WATER PERMIT NO. 6315-3

Remarks: Reconstruction of Lake Henry dam

Water Permit Application No. 6315-3
 SD Dept. of F&P
 Lake Henry Dam
 (Preliminary Plans)

CONSTRUCTION PLANS FOR LAKE HENRY DAM RECONSTRUCTION DEPARTMENT OF GAME, FISH AND PARKS SCOTLAND, SOUTH DAKOTA OSE No. GSD971003I GFP No. W98 12 01B

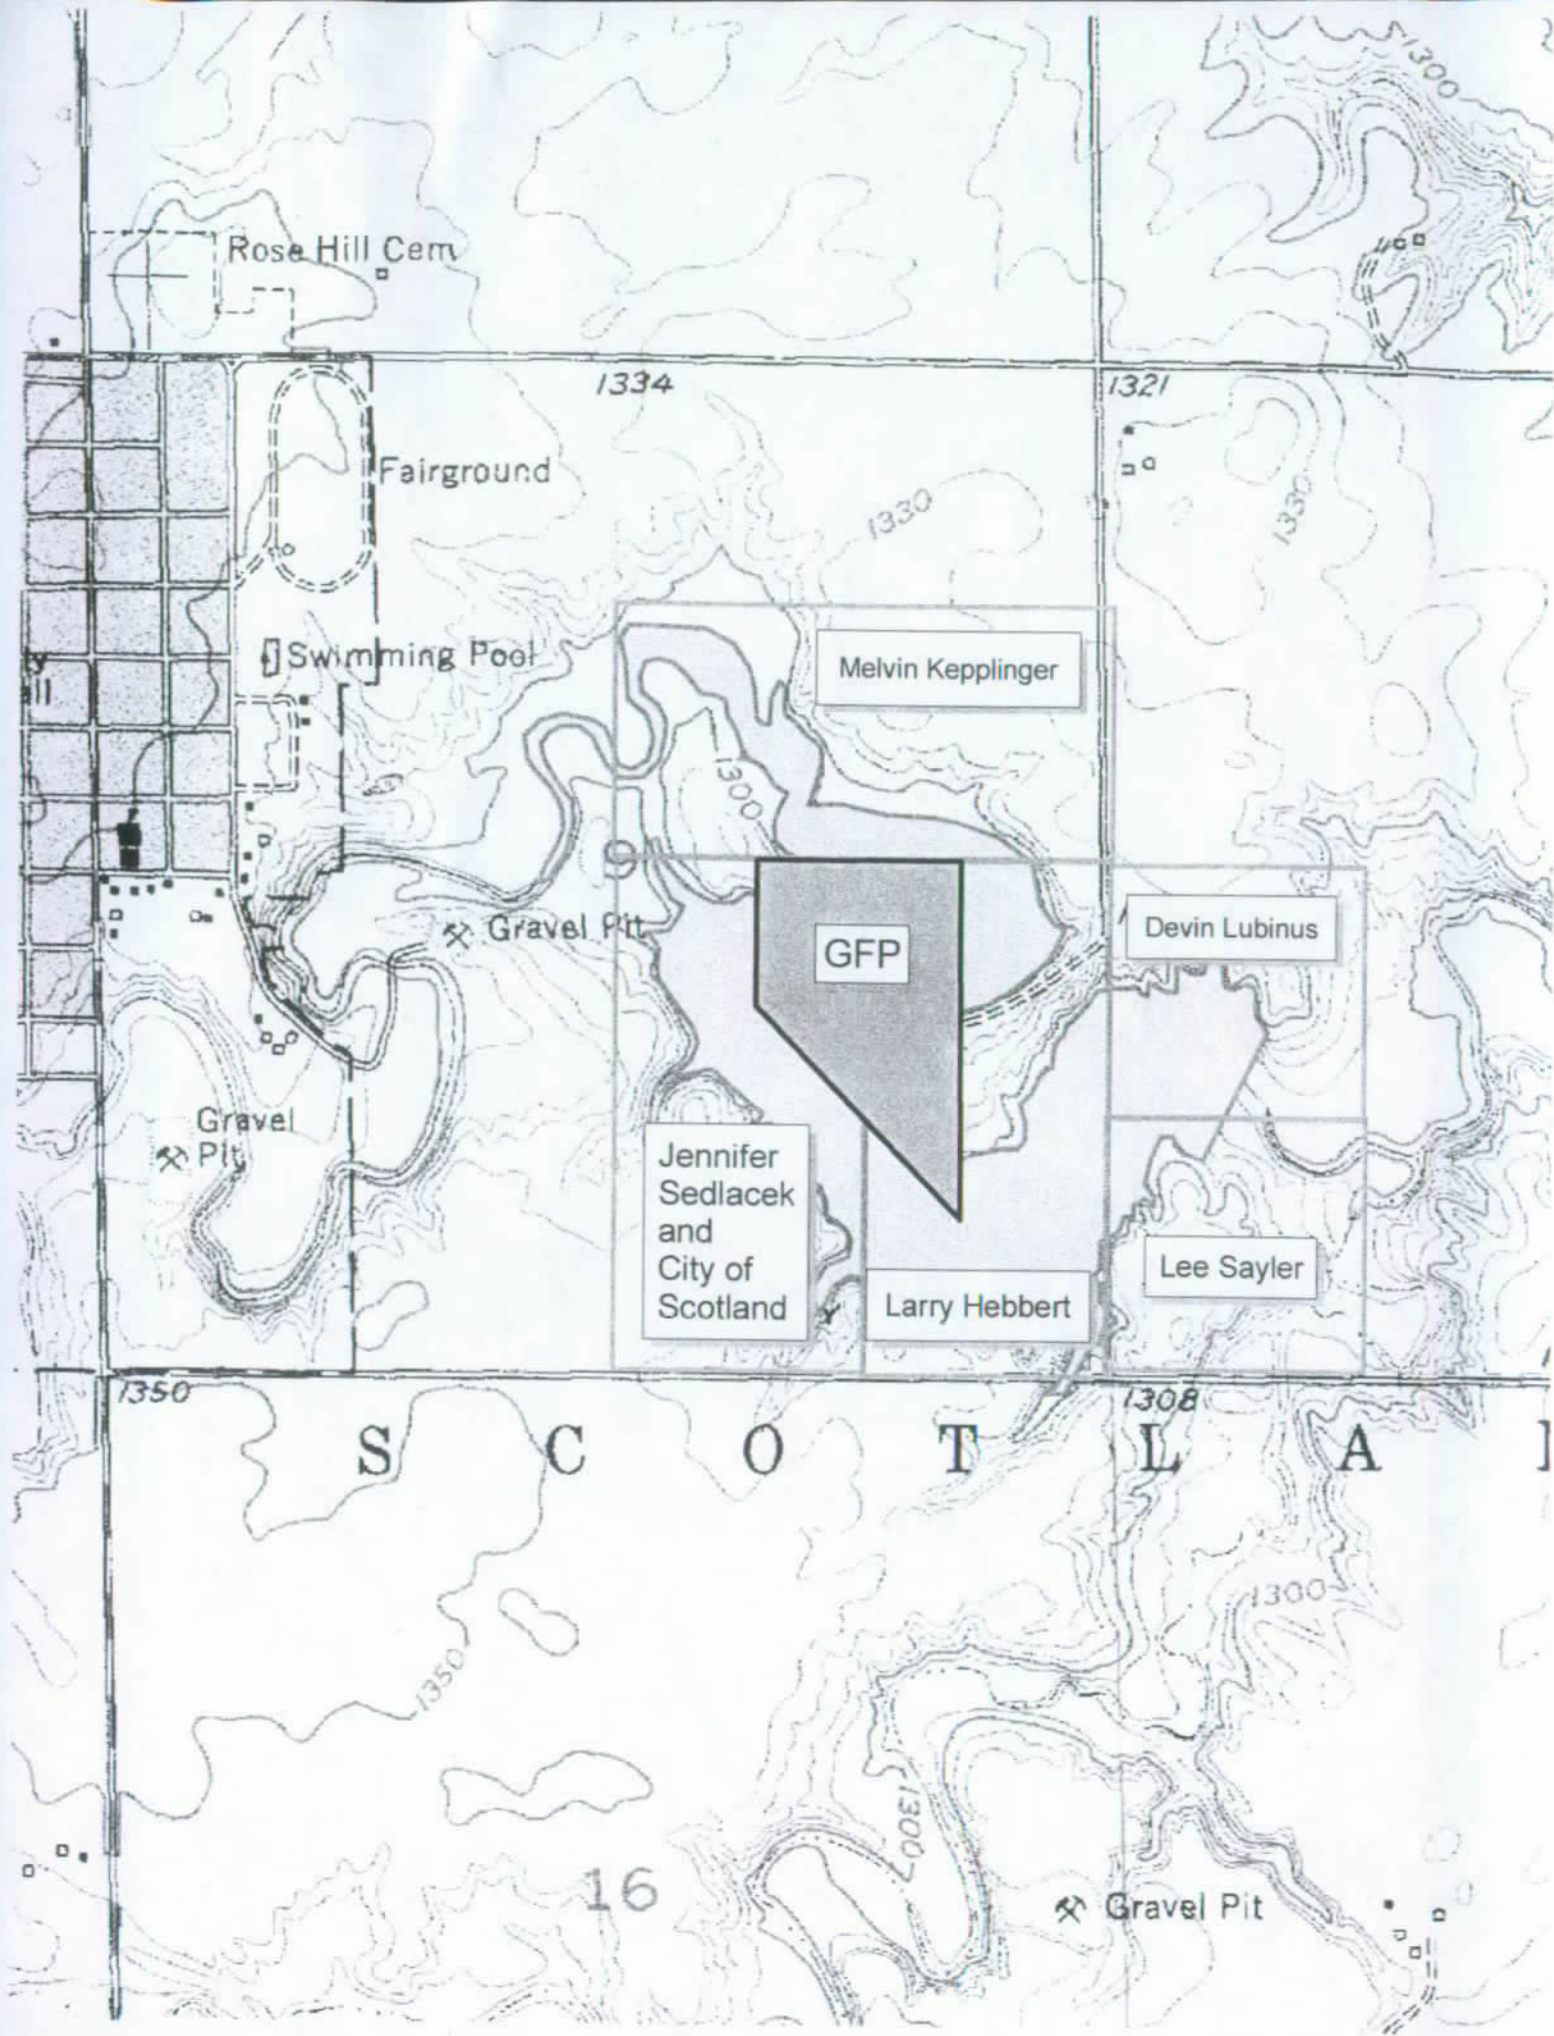
Top of Dam Elev. - 1299
 2nd Spillway Elev. - 1294
 P. Spillway Elev. - 1290
 D/S Emb Toe Elev. - 1254

Cat. 2 - Significant Hazard

Cat. 2 - Intermediate Size - 0.5 PMF unless 74:02:08:07.02
 qualifies

50% PMF = 40,000 cfs
 10% PMF = 7,800
 100 year = 1900

$Q_{100} = 132 A^{.65} S^{.46} Si^{-.67}$

$= 132 (39)^{.65} (10)^{.46} (3.33)^{-.67}$
 $= 132 (10.82) (2.88) (0.45)$
 $= 1850 \text{ cfs used } 1900 \text{ cfs}$

Spillway Capacity - Need Final PIS

1. Topo Map - No-Need Ownership New Land
2. Dam Axis Profile - OK
3. Max X-Sec - Top of Dam Elev 1299
4. Area Capacity - OK
5. Outlet Details - OK
6. Spillway Rating - No Need Final PIS
7. Spillway Details - " "
8. Specs - OK
9. EPP - N/A Cat. 2 - May ask for one

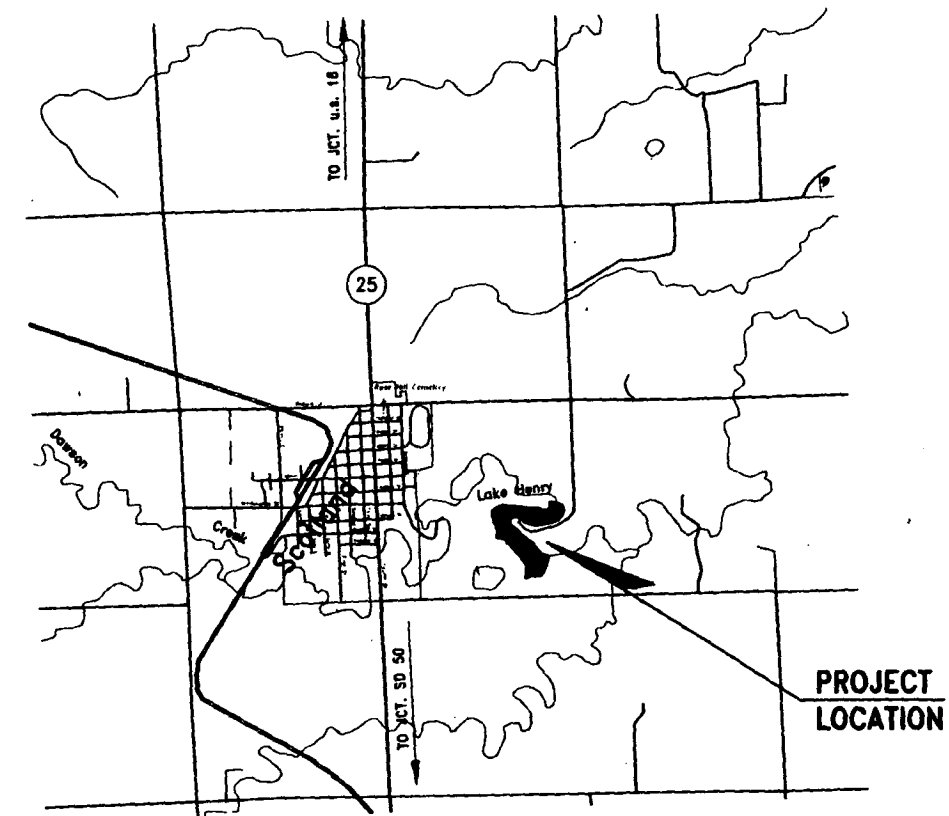
I met with Leslie Petersen and Jeff Peters regarding the application they filed for reconstruction of Lake Henry. I explained that the project location on the cover page of the construction plans prepared in September 1997 is not the same as the location of the map prepared by Jeff Peters. The newer map shows the dam location approximately 1000 to 1250 feet downstream of the original dam site. I explained that we were concerned that the new reconstruction plan is at a different location than the design that we received. Mr. Peters stated that the 1997 construction plans were at the same location and alignment as represented on his map and is the location the dam will be built.

The Water Rights Program is in receipt of the water right permit application filed by the Department of Game, Fish and Parks for reconstruction of the Lake Henry dam. Jeff Peters and you confirmed that the dam will be located as shown on the USGS quadrangle map prepared by Mr. Peters and that the preliminary construction plans, dated September 1997, are for the location and alignment as shown on Mr. Peters' map.
